Reference: TR 84 – 15

Outside 159 The Parade (Island - Island Bay Medical Centre)

Proposal: Additional Mobility Park

PROPOSED TRAFFIC RESOLUTION

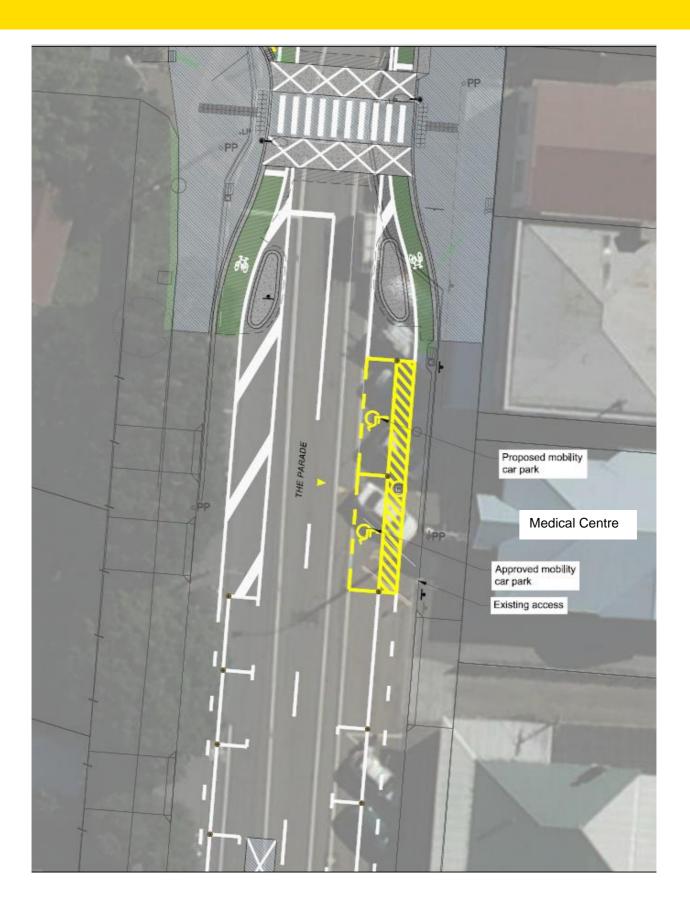
Information: The Island Bay Cycleway traffic resolutions were approved by Council at its meeting on 24 June 2015 resulting from the consideration of a report by the Island Bay Cycleway Working Party. Following discussion with the medical centre, the Working Party recommended that an additional mobility car park be established outside the medical centre. The attached resolutions give effect to this recommendation. If approved, this will provide two mobility spaces at this location.

The design code, NZS 2890-6:2009, states that parallel bays for mobility users should be 2.4m wide by 7.8 metres long. This length requirement means that the parking provision in front of the medical centre reduces from two normal spaces and one mobility space (total of three carparks) down to two mobility spaces only as there is insufficient remaining length to accommodate another car park.

Delete from Schedule A (Time Limits) of the Traffic Restrictions Schedule

Column One	Column Two	Column Three
The Parade	P60 Monday to Saturday 8:00am - 6:00pm	East side, commencing 39.3 metres south of the northern kerbline of Medway Street (Grid Coordinates X=1748394.2 metres, Y= 5422525.8 metres) and extending in a southerly direction for 11 metres.

Add to Schedule B (Class Restricted) of the Traffic Restrictions Schedule

Column One	Column Two	Column Three
The Parade	P60 Monday to Saturday 8:00am - 6:00pm, Vehicles Displaying an Operational Mobility Permit Only	East side, commencing 34.6 metres south of the northern kerbline of Medway Street (Grid Coordinates X=1748394.2 metres, Y= 5422525.8 metres) and extending in a southerly direction for 15.6 metres.
